Dear Reviewer #1,

Comments from Reviewer #1

The authors of manuscript esurf-2021-72.

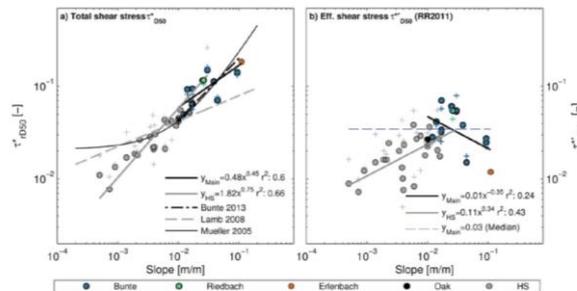
- **Comment 10:** Line 171: The choice of Teta_crit is quite crucial as you use it for plotting your results as a function of transport stage T and compare it with many other results taken from Auel et al 2017. Please elaborate in detail how you derived this value. You have a fixed bed. What did Schneider and Shahmohammadi use in their studies? Auel et al. 2017 list a large variety of these values in their Table 3 and state: *most laboratory studies investigated motion of isolated particles moving on top of a bed of similar roughness size, for which $\theta_c = 0.008$ to 0.01 were determined (Fenton and Abbott, 1977; Dancey et al.,2002).*

You also investigated isolated particles over a fixed bed of similar roughness size. Therefore, the choice of 0.03 is too high from my point of view. At least you should perform a sensitivity analysis of your results by varying teta_crit in order to check the effects on your results.

Response: Thanks to the reviewer for these careful comments. Indeed, it is quite crucial and difficult to obtain the critical Shields parameter $\Theta_{Critical}$ precisely. Auel et al. (2017) list some values of $\Theta_{Critical}$ based on a large number of lab studies, indicating that $\Theta_{Critical} = 0.008$ to 0.01 were determined (Fenton and Abbott, 1977; Dancey et al.,2002) in the case of motion of isolated particles moving on top of a bed of similar roughness size. However, $\Theta_{Critical}$ in the present study should have a larger value than 0.008 to 0.01 due to different bed roughness conditions.

Given the fact that the experimental conditions in this paper are more comparable to those described by Schneider et al. (2015), the critical Shields parameter $\Theta_{Critical}$ in our flume experiments is assumed to be 0.03.

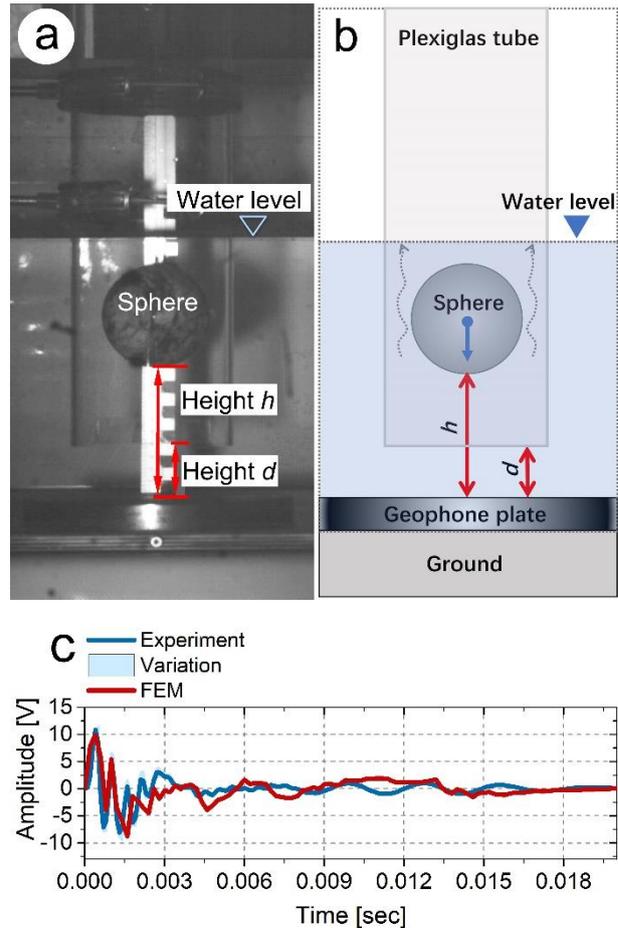
- **Comment 16:** Line 293, line 308, line 318, Fig 8b, Fig 9b, Fig. 10b. Please elaborate more on the difference between FEM and lab experiments. For me it looks like the results do not match at all. With the FEM I would expect the you reach results close to the still water experiments. How did you calibrate the FEM model?

Before performing the numerical simulations, the FEM model had been calibrated with results obtained from the previous lab experiments (drop tests) with quartz spheres (see below, Chen et al. 2021), which is not shown in the present paper. To make this part more understandable, some details about FEM model have been added in Appendix A (L150-151, L558-574).
